This letter is in response to your inquiry of November 16, 1982, regarding the corner positioning and proportions of section 2, T. 23 S., R. 8 W., Willamette Meridian, Oregon, as shown on the plat submitted by you. The problem to be addressed is somewhat complex due to the chain of original surveys, retracements, and/or resurveys in this area.

William W. Glenn  
Chief, Branch of Cadastral Survey

I recently received a copy of your survey plat of Section 2, T23S, R8W. Although your narrative was quite informative, it failed to mention why you used the B.L.M. brass cap at the SE corner of Section 2 instead of the State's. According to your record distance from the only remaining original bearing tree, neither corner pipe fits the original G.L.O. call. This may seem like a minor point, but we have surveys and property in this area based on the State's corner position which can be affected by your survey. We were not aware B.L.M. had set a corner pipe in a different location until we reviewed your survey plat.

( ) Parenthetical Distances,  
Hathorn Plat

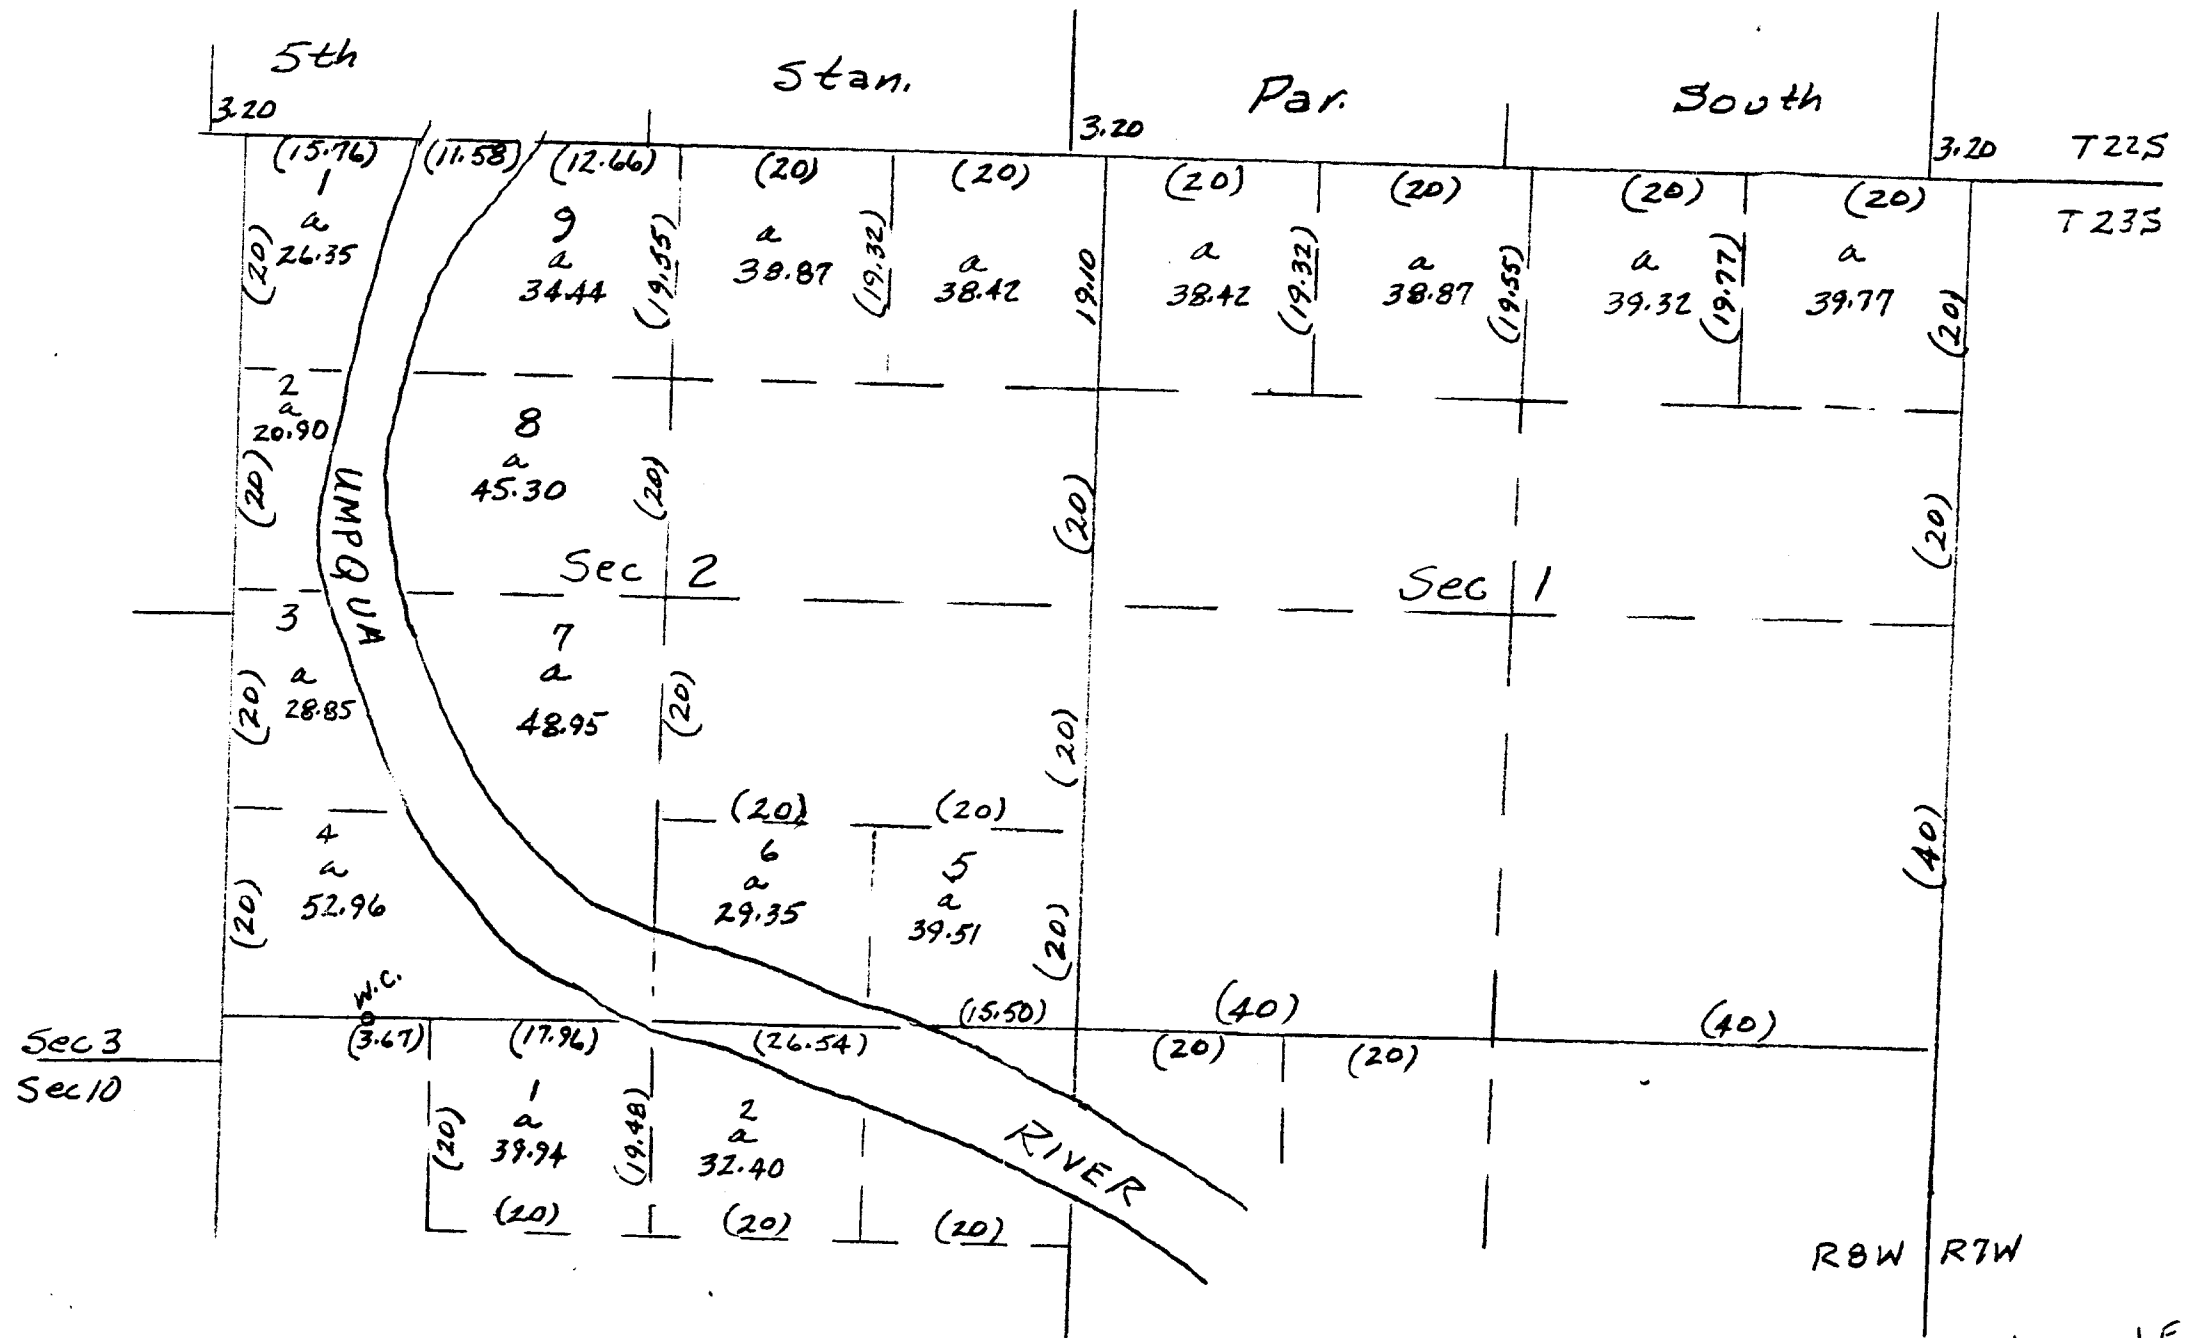
1. The standard corner of sections 1 and 2 should be restored at single proportionate distance between the corner of sections 35 and 36 (Brooks) and the standard corner of Tps. 23 S., Rs. 7 and 8 W. (remonumented by Brooks). The standard  $\frac{1}{2}$  section corner of section 2 should be restored at single proportionate position, between the corner of sections 35 and 36 and the standard corner of sections 2 and 3. The (Brooks) corner of sections 35 and 36 thus exercises full control, as though it were an original monument, in accordance with Section 6-28 of the Manual.

2. The  $\frac{1}{2}$  section corner of sections 1 and 2 should be restored at single proportionate position, based on the Whipple retracement, between the restored standard corner of sections 1 and 2, and the corner of sections 1, 2, 11, and 12.

3. The 1/16 section corners and west  $\frac{1}{2}$  section corner of section 2 should be established at equal distance positions between the closing corner of sections 2 and 11, and the standard corner of sections 2 and 3, and on the east boundary of section 3, controlled for alignment by the Whipple corners.

4. The point for the south  $\frac{1}{4}$  section corner of section 2 should be restored at single proportionate position between the corner of sections 1, 2, 11, and 12, and the "crossing closing corner" (established by Peterson), at the intersection of the section line and west boundary of D.L.C. No. 40. This procedure is slightly anomalous to the usual practice concerning the control exercised by closing corners, for these reasons:

One other item is brought to your attention. The fifth paragraph of Section 5-41 of the Manual specifically states that the original closing corner controls proportions along a closing line, not the true point of intersection. Your plat indicates that you used the true point of intersection to control proportioning along the line between sections 2 and 11. That procedure is incorrect.

We have prepared two sketches of section 2, one showing the parenthetical distances used to determine the areas of section 2, as shown on Hathorn's plat. The other shows the proportionate distances (in feet) based on the data shown on your plat. These distances should not be construed as other than an indication of the proportionate positions discussed above.
